BWB A CAF GROUP COMPANY

Delin, California Drive, Castleford

Drainage Layout Sheet 2

Project - Originator - Zone - Level - Type - Role - Number	Status	Rev
P26014-BWB-EX-XX-DR-C-0502	A5	C04

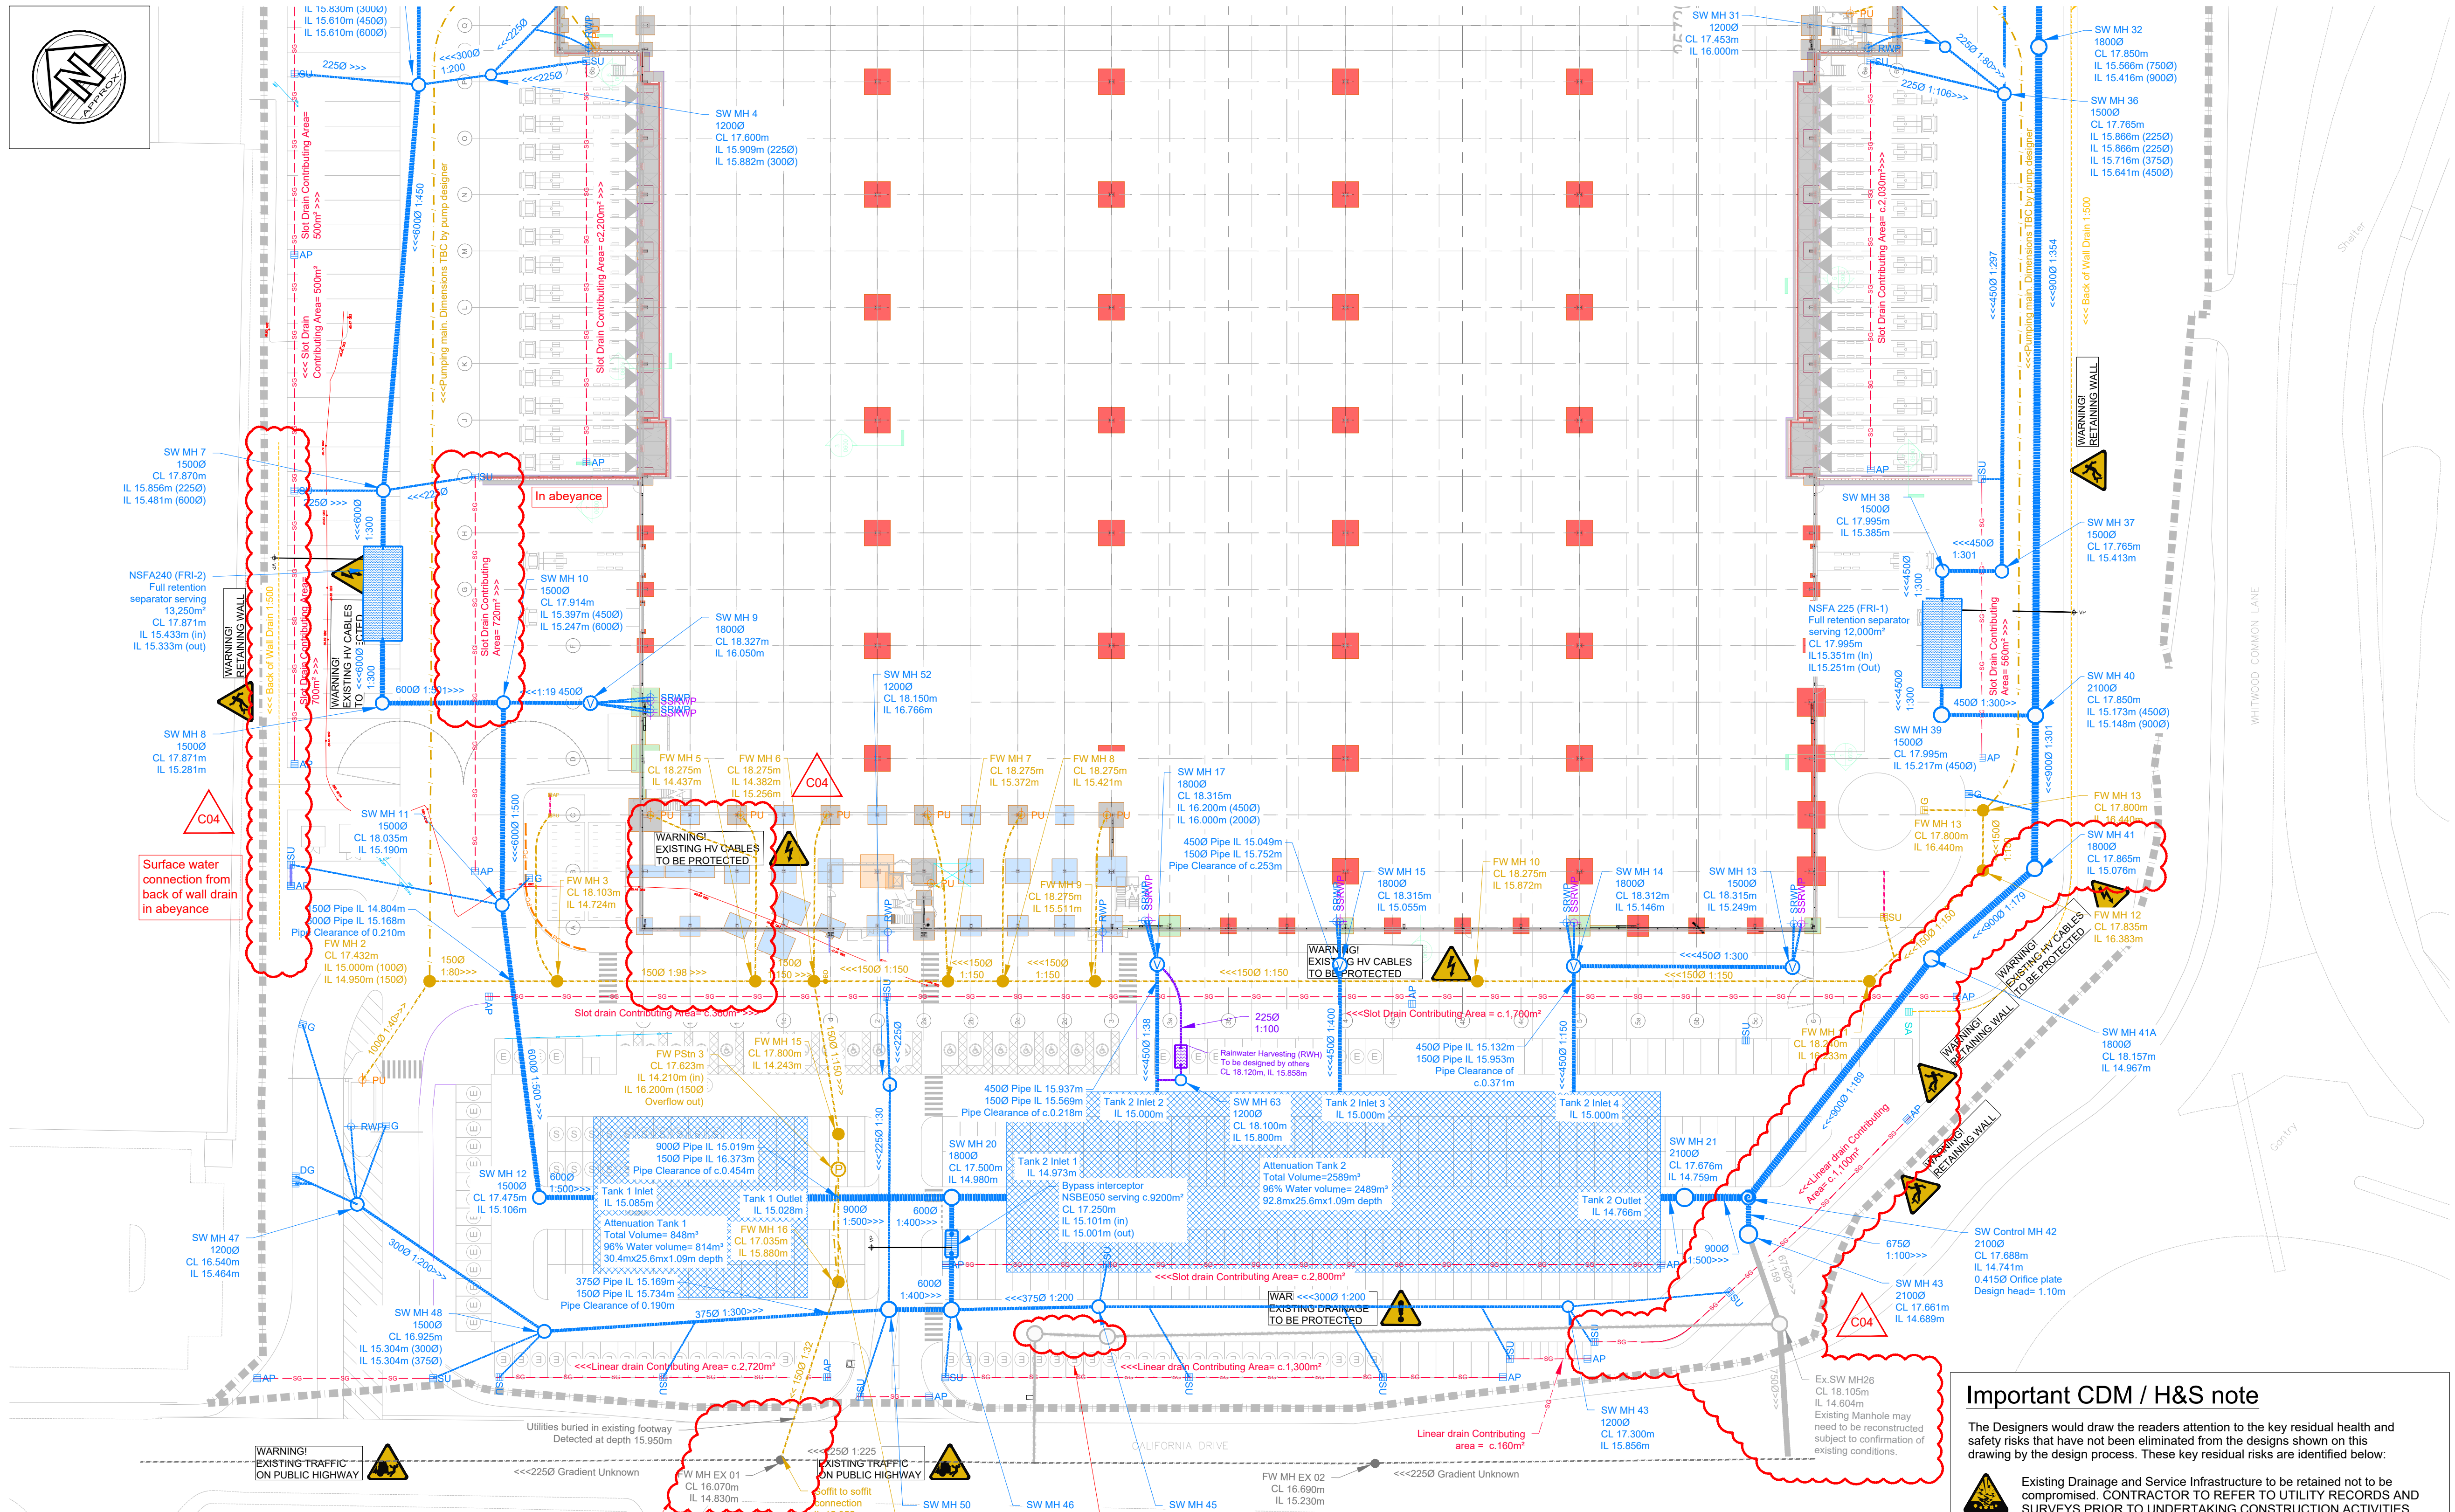
- Key Revisions as requested by Winvic:**
- Removal of back of wall drain along car park king post retaining wall; unable to be constructed due to space constraints.
 - Accompanying soakaway at West end of
 - SW MH 41 added to avoid retaining wall foundation and pipe clash
 - SW MH 42 relocated to accommodate 90 degree connection to adjaction manholes.
 - SW MH 43 added as connection point to existing pipe network.
 - FW MH 4 removed and FW popup connection to FW MH 4 combined into FW popup connection to FW MH 5.
 - Back of wall drain added at Northeast boundary.
- Other revisions:**
- Ex.SW MH 26 and connection amended following receipt of drainage survey information.
 - SW MH 21 to Ex.SW MH 26 pipe diameter amended to 675mm.
